Service Bulletin

Incorporation of GA8 Flight Manual Amendment, dated 3 December 2002.

Document: Service Bulletin SB-GA8-2002-03

Fig. 6-3a GA8 Loading Trim Sheet

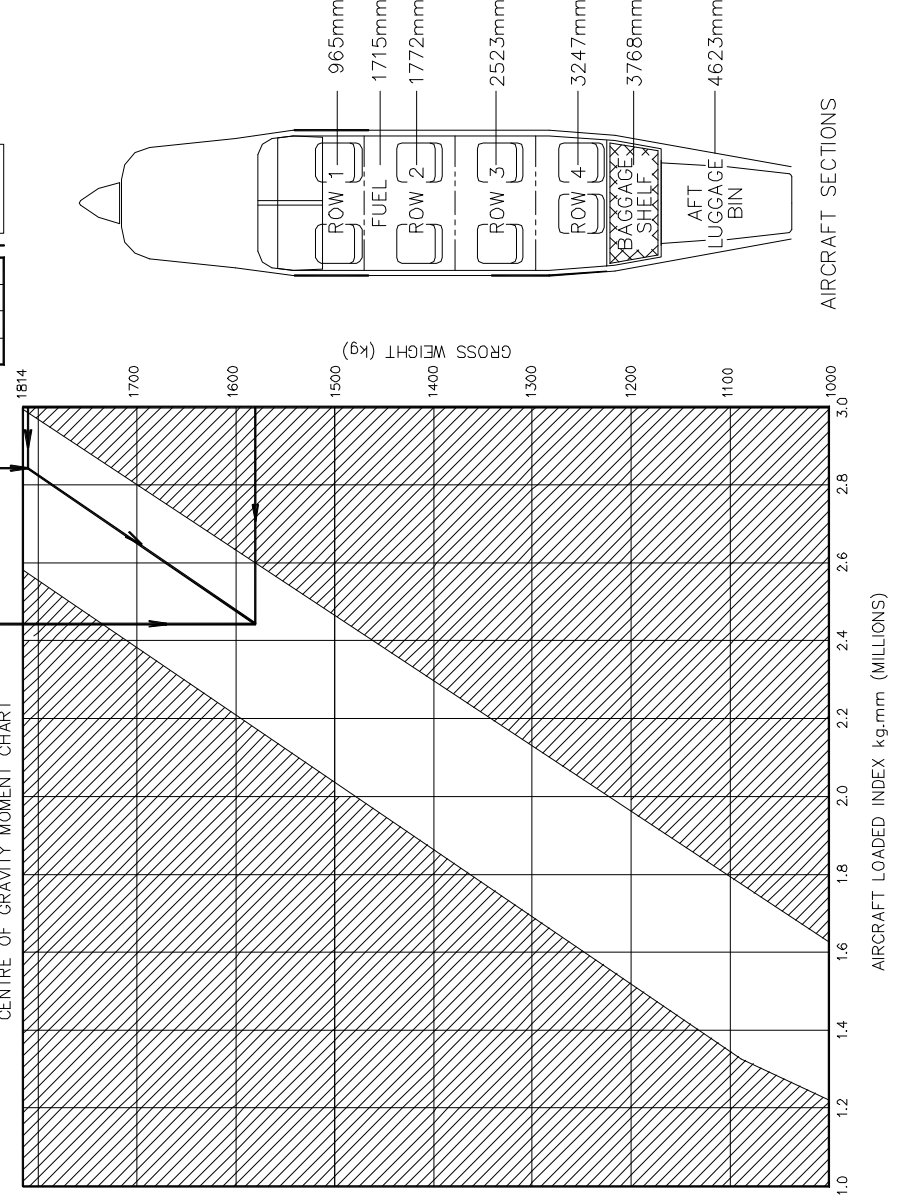
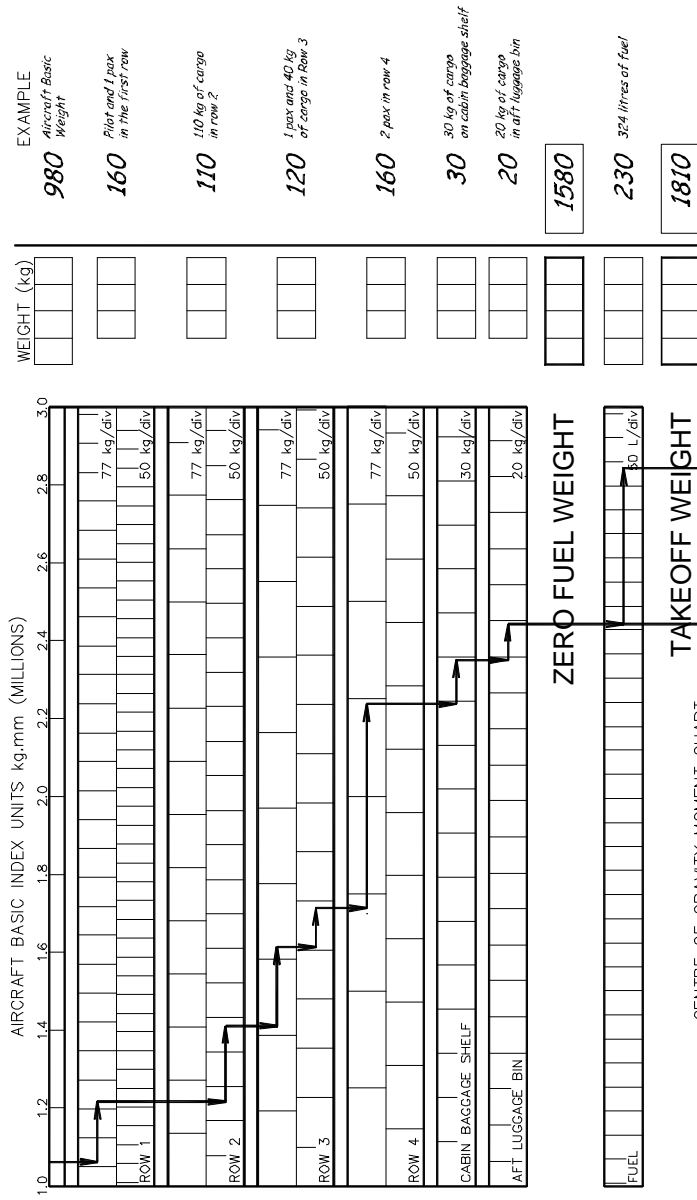
The 'GA8 loading trim sheets' have been constructed with an incorrect fuel moment arm.

Amendment Date	Description	Pages Affected	Signature Date of Incorp'n
0	Initial Issue	All	
1	General Improvements to most sections. Dual units incorporated. Performance data changed. Airspeed limitations changed.	Sections 1, 2, 3, 4, & 6	
2	General Improvements to all sections. Engine limitations changed. Performance data changed.	All	
3	General Improvements to most sections. Engine limitations changed. Fold out performance charts included.	Sections 1, 2, 4, 5, 6, 7, & 8	
10 Sep 2001	Date amendment system incorporated on all pages, general amendments and corrections, engine & performance data changed.	All	
15 May 2002	Imperial unit performance and weight charts added. Minor changes to other sections.	Sections 1, 2, 4, 5, 6 & 8	
3 Dec 2002	Revised weight and balance trim sheets.	Section 6

The flight manual amendment, dated 3 December 2002 is to be incorporated before further flight.

Replace pages ii, iii, and 6-7/6-8 in the GA8 Aircraft Flight Manual, C01-01-01.
